Shop Drawing Submittal Review

Project Name: Webster University-**ISB**

Copies	No.	Description
1 PDF	224216P02	(Submittal No.'s)
		(Cannon #22 4216.16-001) - (Paric #15051-) - (WES #607)
		➤ Commercial Sinks
		• Clinical Service Sink CSS-1
		• Scrub Sink SS-1
		• Sink SK-1
		• Garbage Disposer GD-1
		• Sink SK-2
		• Sink SK-3
		• Mop Sink MS-1
		• Kitchen Sinks KS-1, KS-2, KS-3

SPEC SECTION: 22 4216.16
Commercial Sinks

LKAD Series Drains and Offset Tailpiece

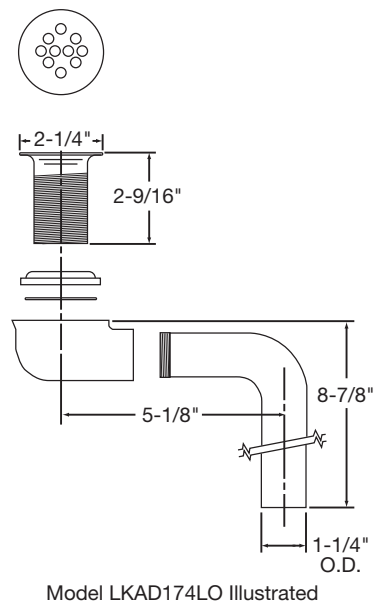
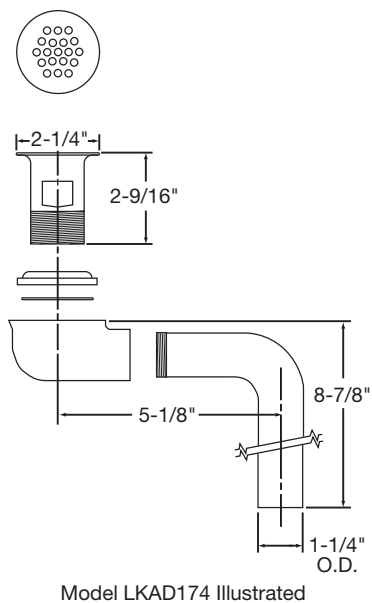
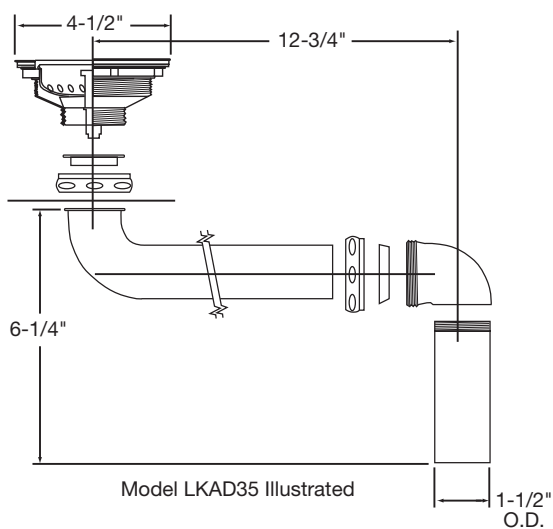
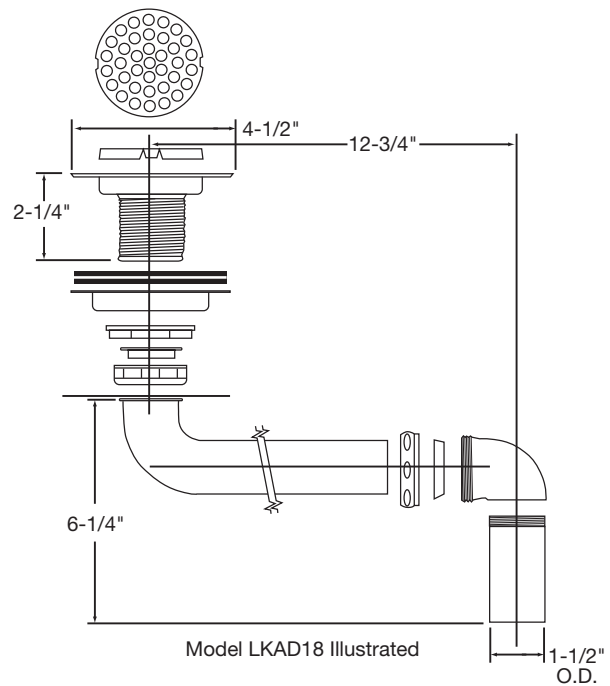
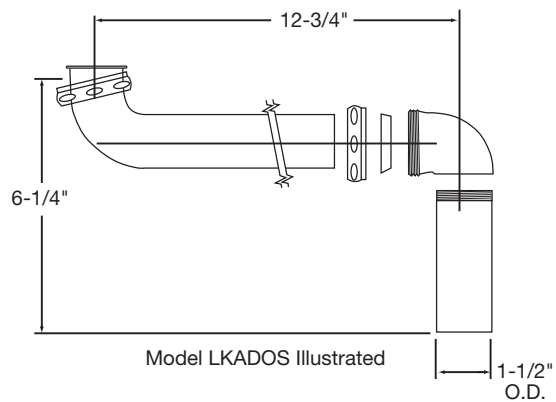
1. Provide under counter waste and supply protective piping covers as required.
Verify requirements with the architectural drawings.
2. Escutcheons are specified to be cast brass. Refer to specification section 220518.

X					Drain Assembly Elkay Model LKAD18	Provide under counter waste and supply protective piping covers as required. Verify requirements with the architectural drawings.
X					P-Trap Proflo Model PFPTB403	
X					Angle Stops BrassCraft Model SCR19XC
